February 19, 2015

ADDENDUM A

Saint James Catholic Church
Phase 1 Renovations and Additions
Kearney, Nebraska
RDG Project No. 2013.203.01, File 35.1

A1.1 INTERIOR ELEVATION 119E
 $3/8" = 1'-0"$

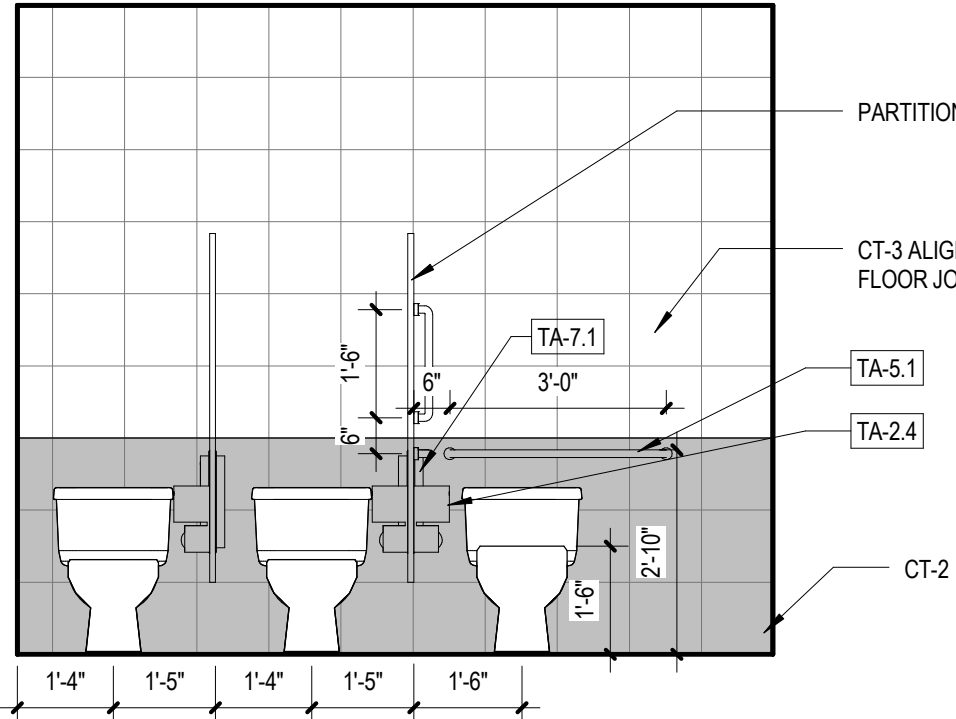
- A. Revise Elevation A1.1, Interior Elevation 119E per attached Supplemental Drawing SDA-02.
- B. Revise Elevation A4, Interior Elevation 120W per attached Supplemental Drawing SDA-03.

PROJECT NUMBER 20144450	DATE 02-18-2015	DRAWING REFERENCED: ADDENDUM NO.:	M02.01 A	SKETCH SDM-02
----------------------------	--------------------	--------------------------------------	-------------	------------------

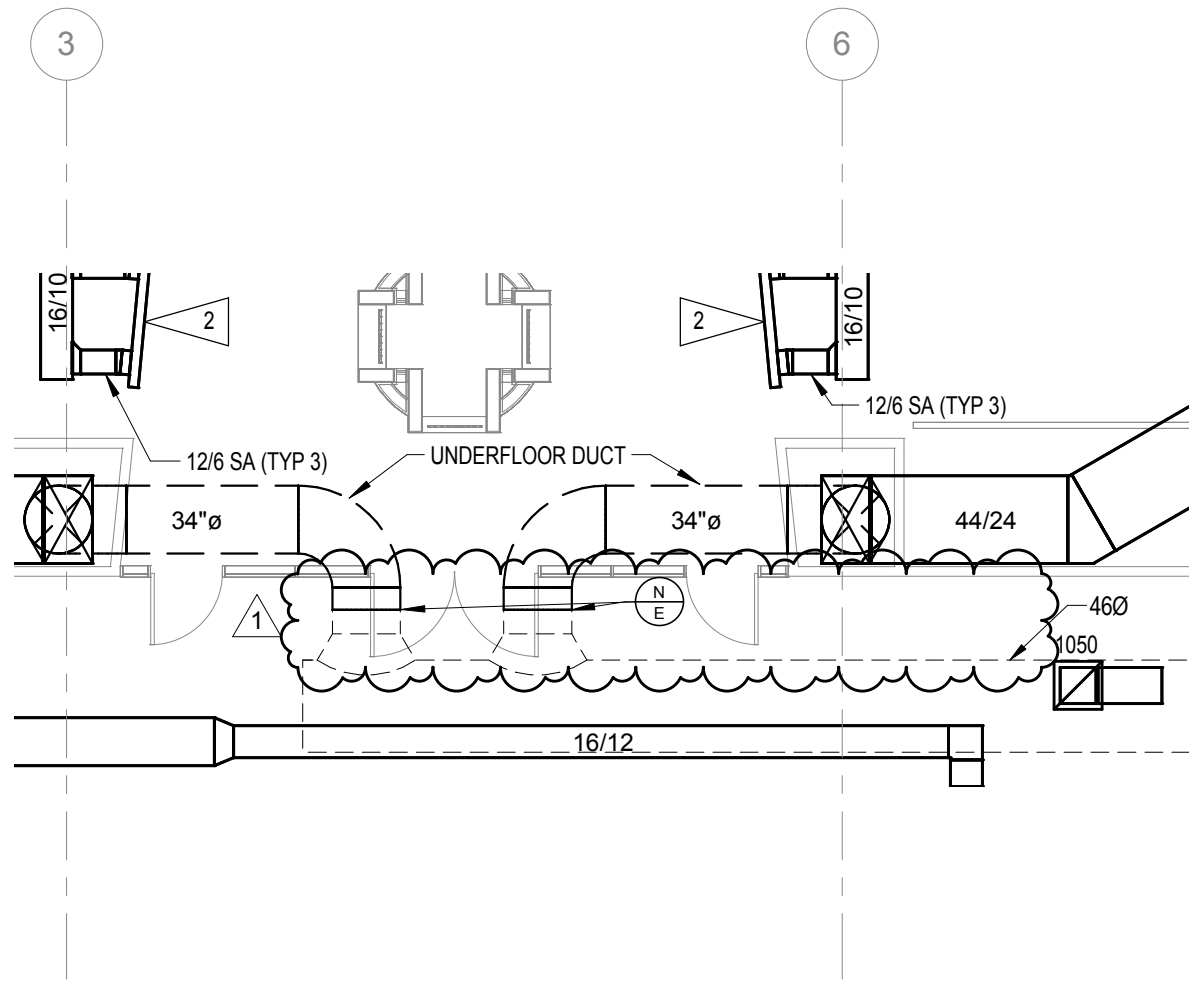
AMD-2 Sheet M02.01 – Floor Plan – HVAC: Modify the location of the new to existing symbol. See attached Supplemental Drawing Sketch Sheet SDM-02 for new location.

SKETCH
SDM-03

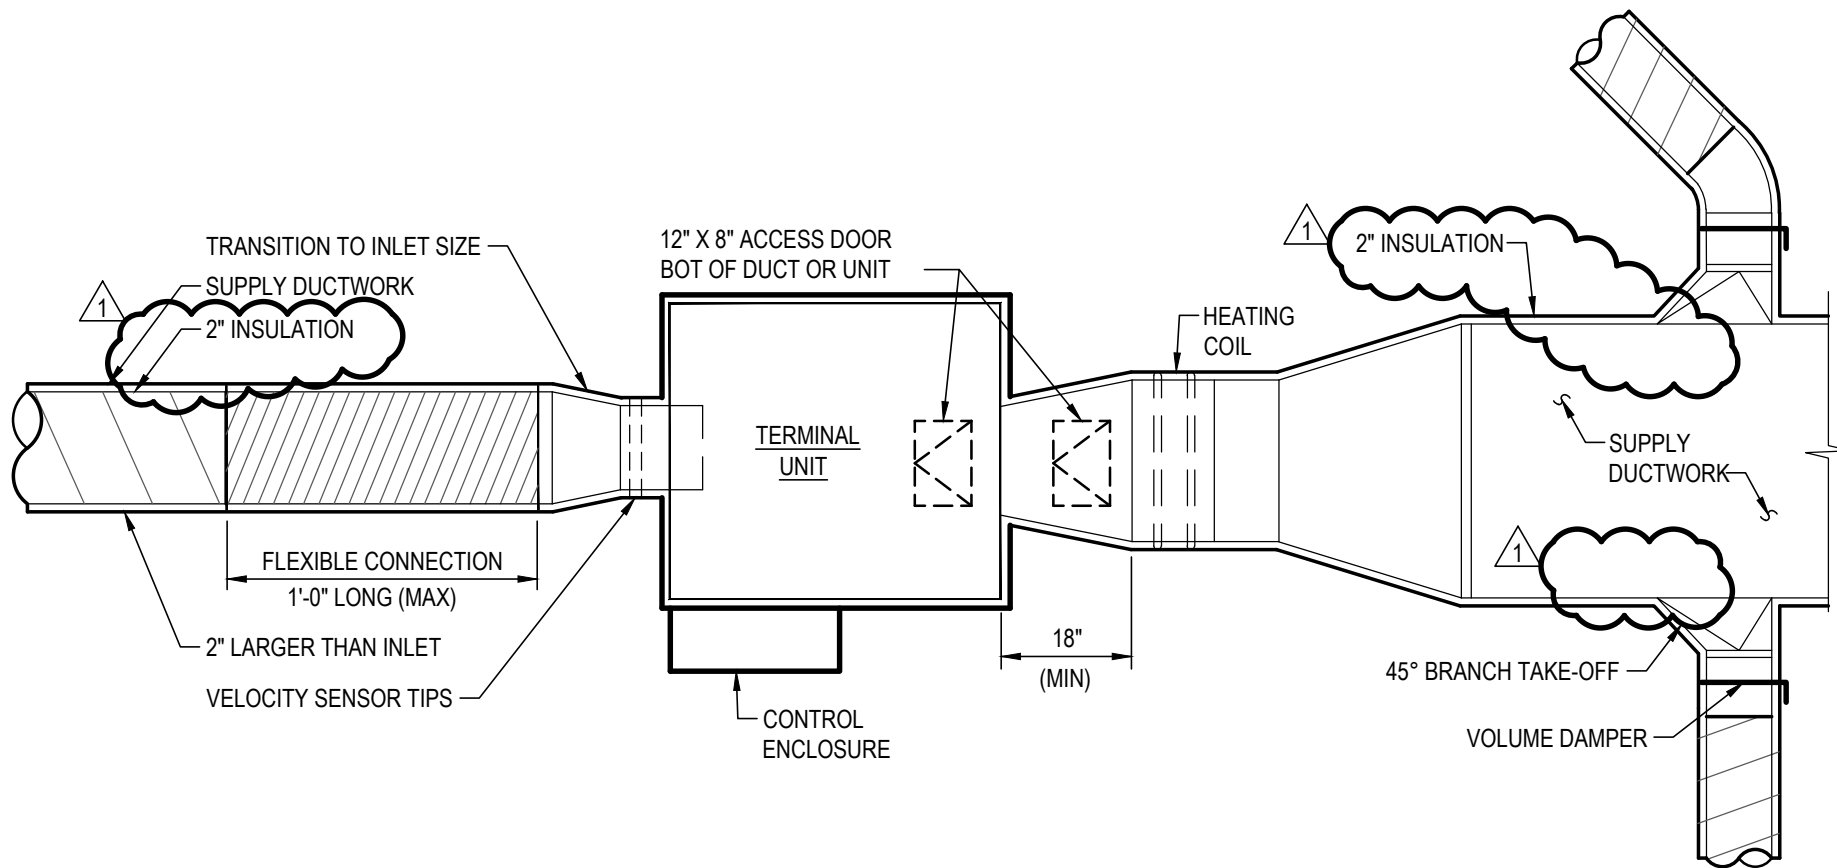
AMD-3 Sheet M05.01 – Mechanical Details: Modify supply air duct insulation thickness. See attached Supplemental Drawing Sketch Sheet SDM-03.

SKETCH
SDE-01

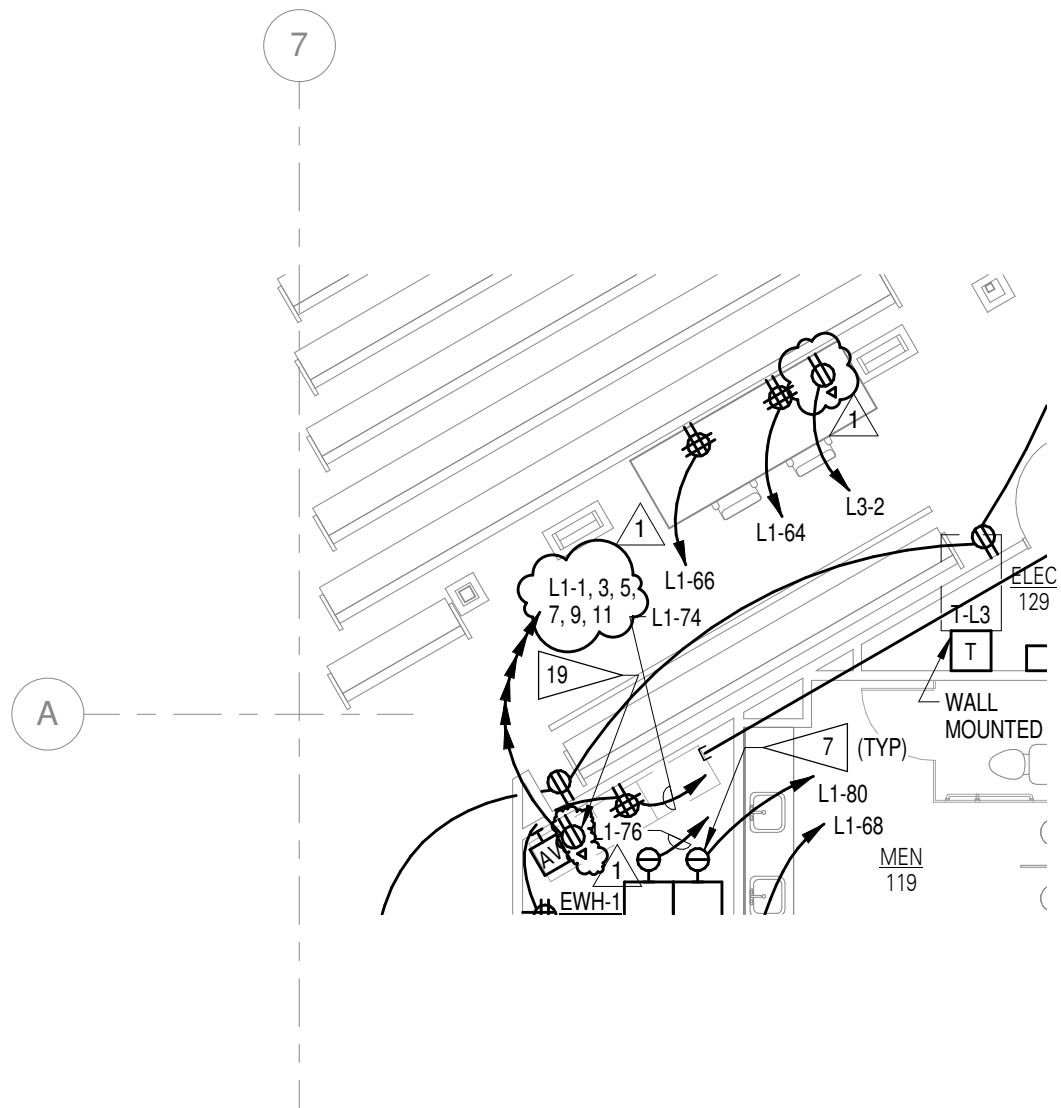
- A. Delete AV floor box and Flag Note 22 at altar location.
- B. Modify three (3) locations to show proper isolated ground duplex receptacle symbol per attached Supplemental Drawing Sketch Sheets SDE-01 and SDE-02.
- C. Modify homerun to read L3-1, 3, 5, 7, 9, 11 per attached Supplemental Drawing Sketch Sheet SDE-02.
- D. Modify two (2) locations for duplex receptacles and AV rough-ins per attached Supplemental Drawing Sketch Sheet SDE-01.

PROJECT NUMBER	DATE	DRAWING REFERENCED:	E01.01	SKETCH
20144450	02-18-2015	ADDENDUM NO.:	A	SDE-03

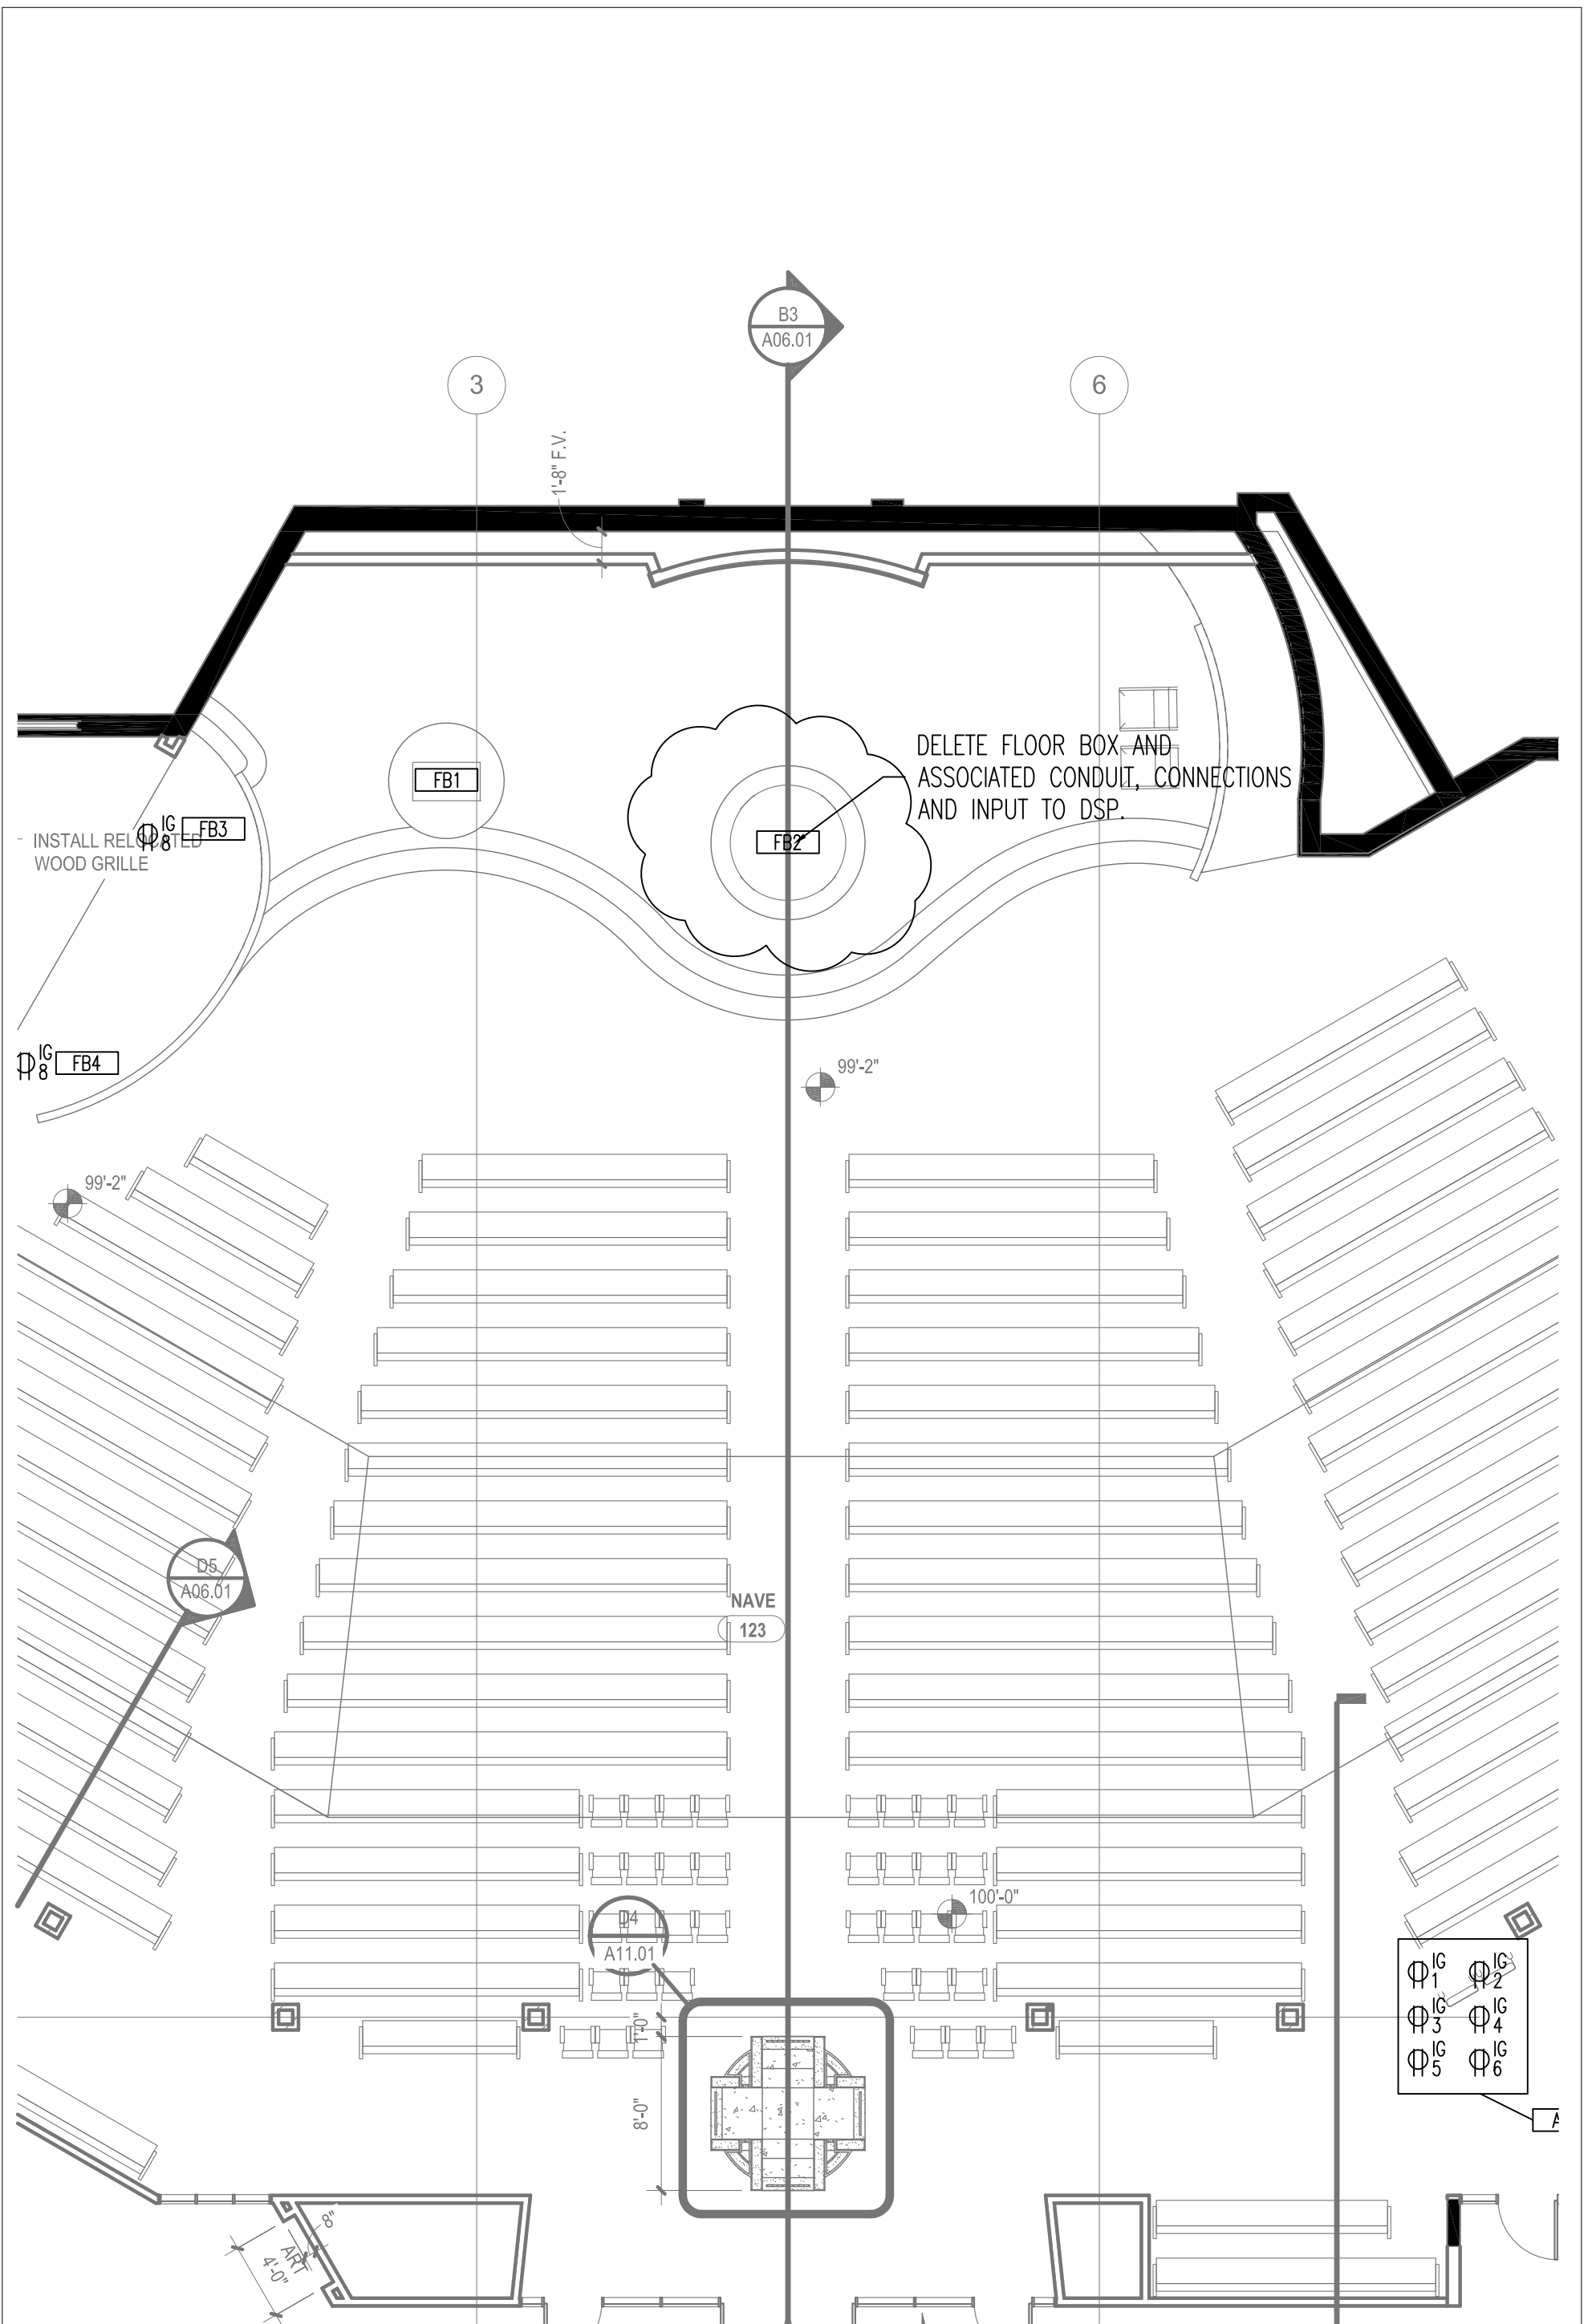
AED-1 Sheet E01.01 – Floor Plan – Lighting: Add notes for Add Alternate No. 8 per attached Supplemental Drawing Sketch Sheet SDE-03.

1. UNDER BASE BID, PROVIDE THE FOLLOWING:
 - A. TYPE 16 ALT AND TYPE 17 ALT IN LIEU OF TYPES 16D AND 17D RESPECTIVELY.
 - B. ADDITIONAL 120V CIRCUIT TO CONNECT TYPES 16 ALT AND 17 ALT IN THE OFFICE AREA.
 - C. ADDITIONAL LIGHTING INVERTER INV-4 TO SUPPORT ADDITIONAL EMERGENCY TYPE 16 ALT AND TYPE 17 ALT LOAD.
 - D. STANDARD WALL SWITCH SENSOR IN LIEU OF TYPE D SWITCH SENSOR.
2. UNDER ALTERNATE BID, PROVIDE ELECTRICAL AS INDICATED ON THIS SHEET.
